Response to Comments Document

ROBLAR ROAD QUARRY

Environmental Impact Report
SCH # 2004092099

Prepared for
County of Sonoma Permit and
Resource Management Department

Comments Figure 1. Landslides inferred from aerial photographs by Ray Waldbaum, RPEG

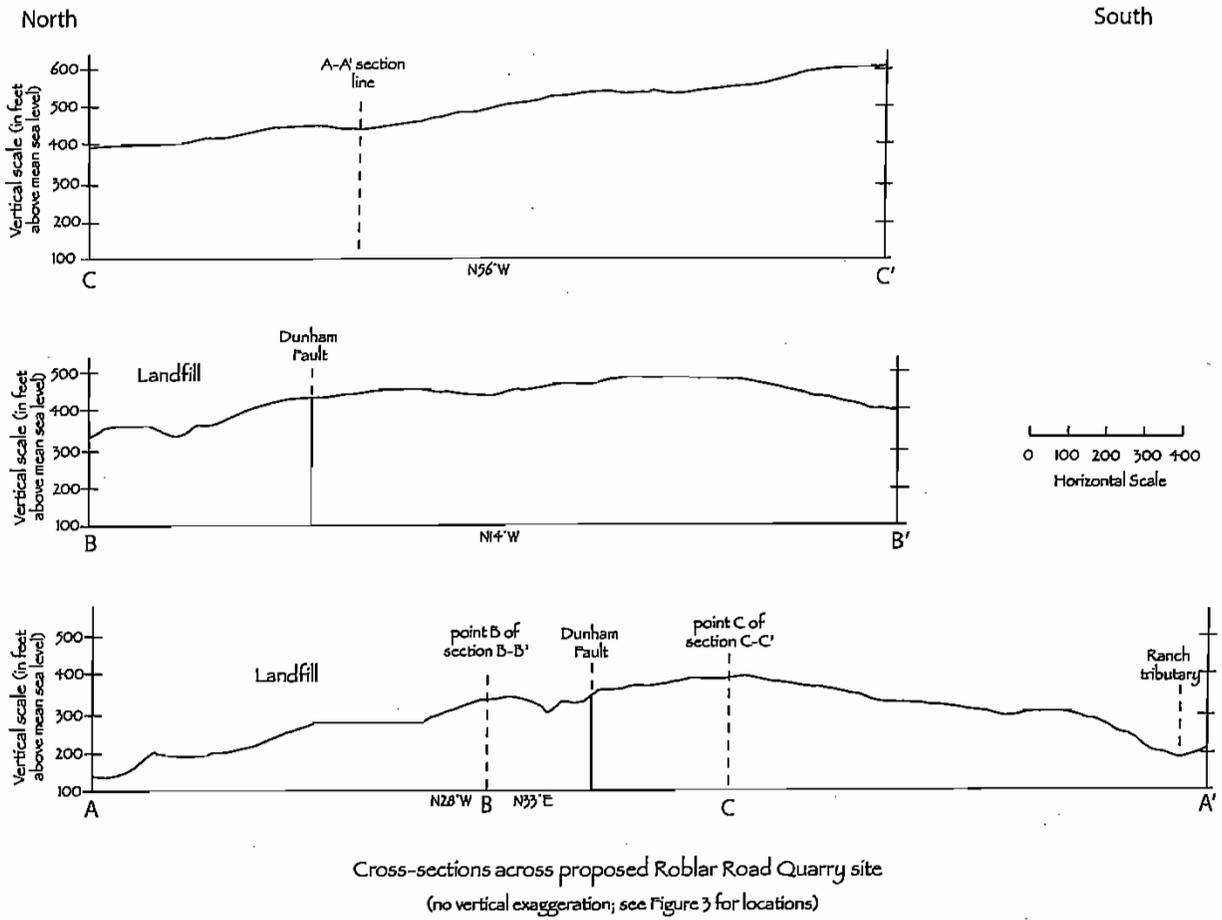
This statement expresses the concern about replacing the present geological buttress to a clearly unstable topography with a oversteepened slopes adjacent to a void (Figure 3). This situation probably equates to a higher potential for catastrophic failure than the 2008 DEIR discloses. A number of possible destabilizing features are left unmentioned and probably unexamined -- including post-quarrying groundwater interactions with geologic units and landfill cells, the location and impact of fracture zones within the basalts, especially quarry cutslope fracture zones, the interaction of the local active and potentially active faults, and the potential for earthquakes to generate landslides, whether or not onsite faults experience secondary slip.

Contrary to the commenter’s assertion, the project does not replace the existing “geological buttress to a clearly unstable topography with oversteepened slopes adjacent to a void.” For visual context, the commenter is referred to **Figure K-1** on the following page. This illustration was previously presented as Section “L” in Figure III-8 in the Draft EIR Project Description, and is repeated here. This figure is true-scale longitudinal-section through the quarry property and the landfill property, and shows relative distance between the quarry and landfill, and the final quarry slopes. As shown in this figure, as well as the commenter’s own Figure 3 (cross-section B-B’) presented in her letter, the commenter’s reference to “oversteepened slopes adjacent to a void” is a mischaracterization.

Comments Figure 2. Cross sections showing current topography of proposed Roblar Road quarry and old landfill sites, by Jane E. Nielson, Ph.D.

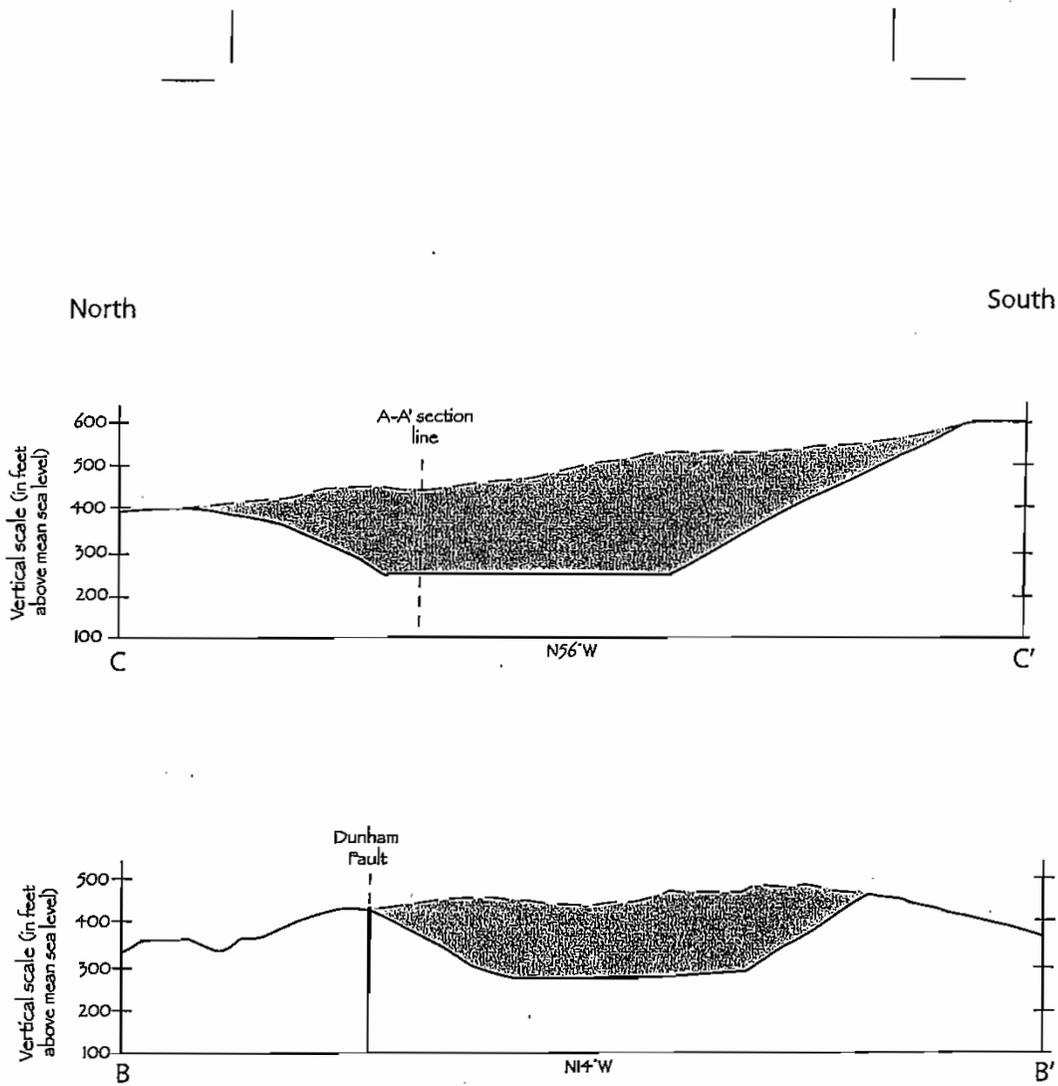
True-scale cross sections of the quarry site as it is today (Fig. 1, attached) show that the old landfill imposed a series of relatively flat benches separated by relatively steep slopes onto the original topography (see Figure 3, attached, for cross-section locations). The benches tend to pond rainwater, and capping soils -- apparently derived from permeable Steinbeck loam series, which occur on many surrounding undisturbed slopes (page IV.C-6) -- allow the collected water to permeate the landfill cells. The highest cell is underlain by less permeable rock, so that water cannot percolate lower and can buildup pressures that add to the potential for hillslope instabilities.

4) True-scale cross sections of the quarry site both before (Fig. 2, attached) and after excavation (Fig. 3, attached) show that the northern quarry wall will intersect part of the Dunham Fault, substantially altering several slope stability factors (see Figure 4, attached, for cross-section locations). The 2008 DEIR's paucity of information on the hydraulic character of the Dunham Fault (Dunham Fault and Relationship to Groundwater section, page IV.C-14) suggests that little or nothing is known. But the Onsite Inactive Fault section (page IV.B-11) states "Hydrologic and groundwater analysis (unspecified) completed for this EIR suggest that the Dunham Fault represents a barrier to groundwater flow." This statement refers to Chapter IV.C, Hydrology, Geology and Water Quality, where an observation of increased water production in the borehole of a monitoring well located on or close to the fault is reported in the Dunham Fault and Relationship to Groundwater section (page IV.C-14).

Figure PC-1
Existing Parcels and Residences - 1 Mile Radius of Proposed Mining Area

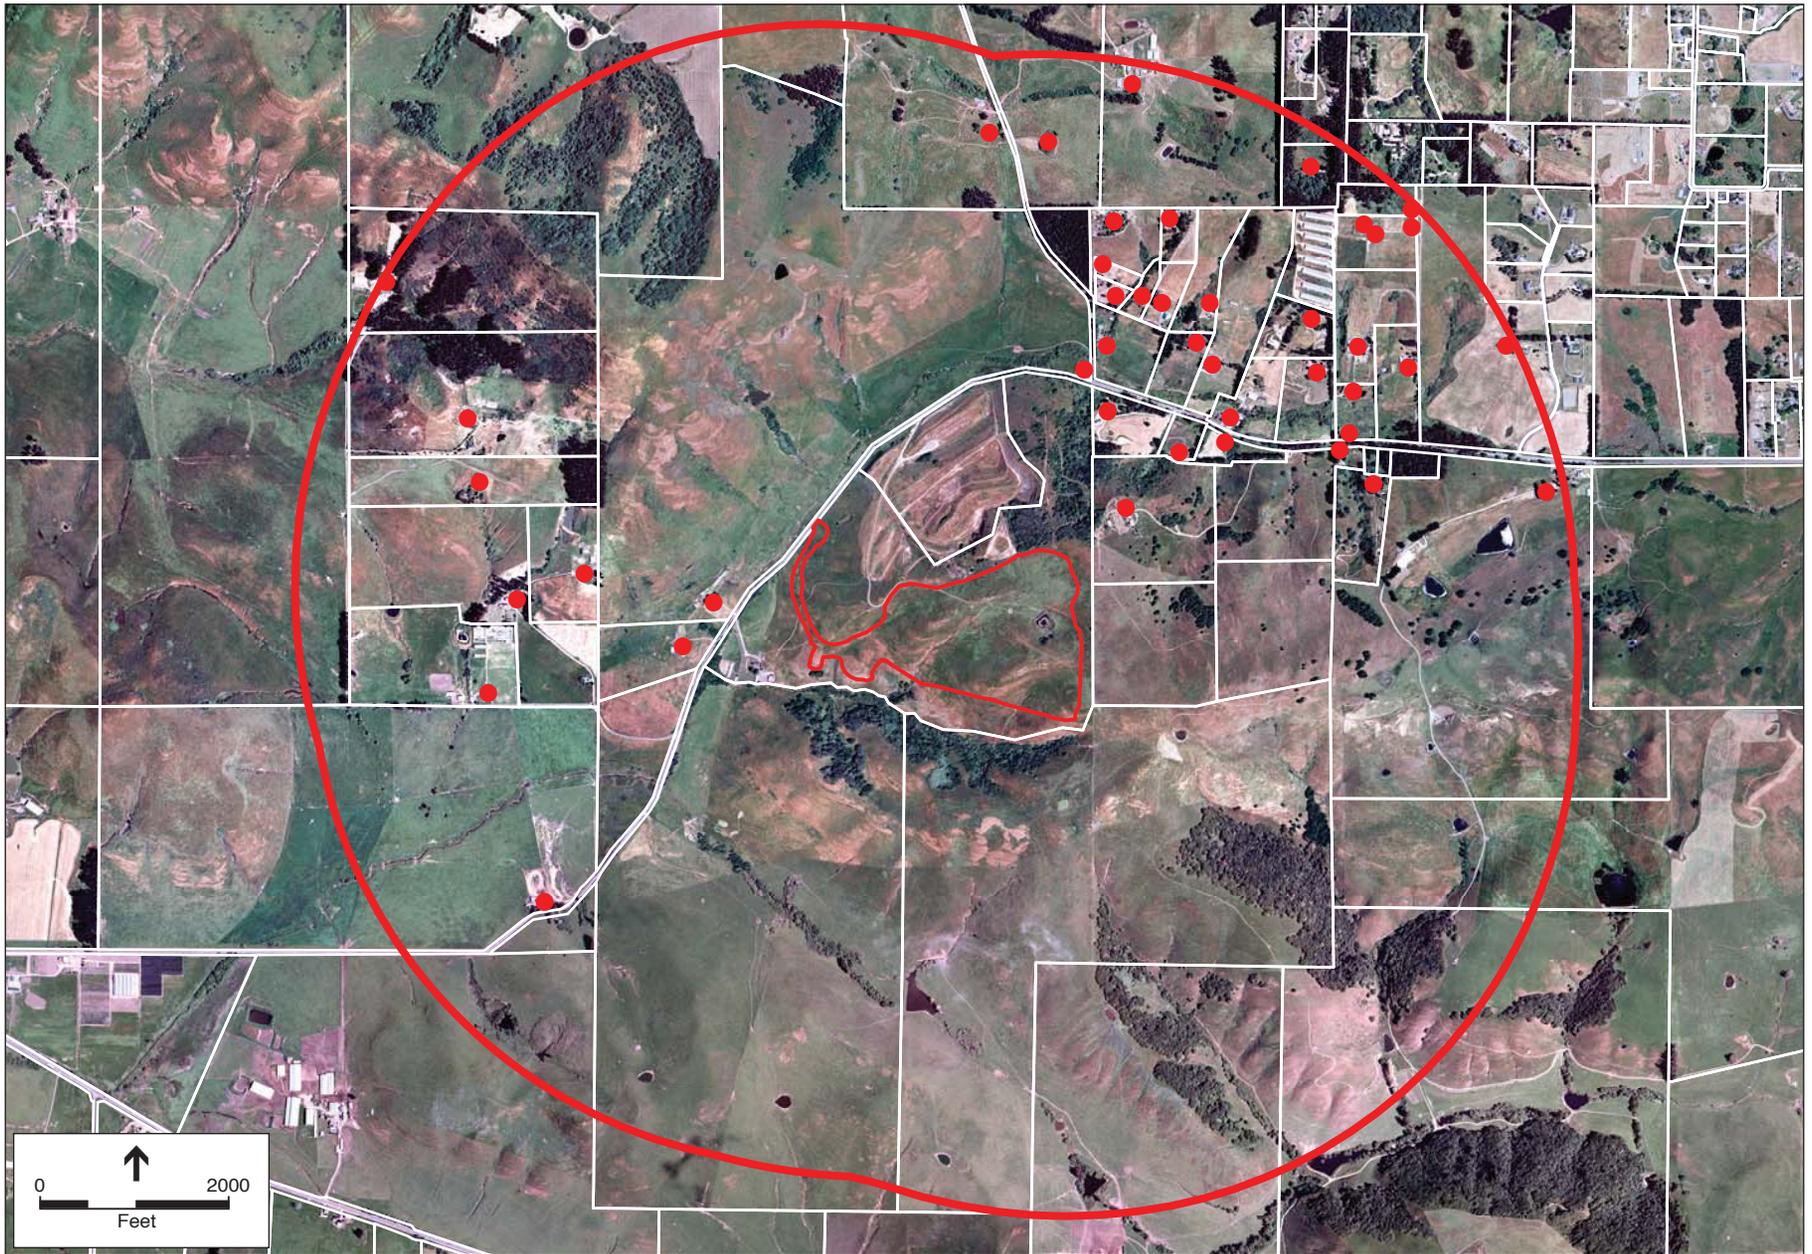
PC-96 The Commissioner requests that the number of residences be shown in an exhibit that shows the ¼, 1/3, and one-mile radius. Existing residences located within proximity to the proposed mining area have been identified through the use of aerial photography and field observation (see Figure PC-1 on the following page). Approximately 43 single family residences are located within a mile radius of the proposed mining area. The majority of these residences are situated to the northeast and over a hill from the proposed mining area (see attached aerial photo). Ten of these residences are situated across Roblar Road to the west.
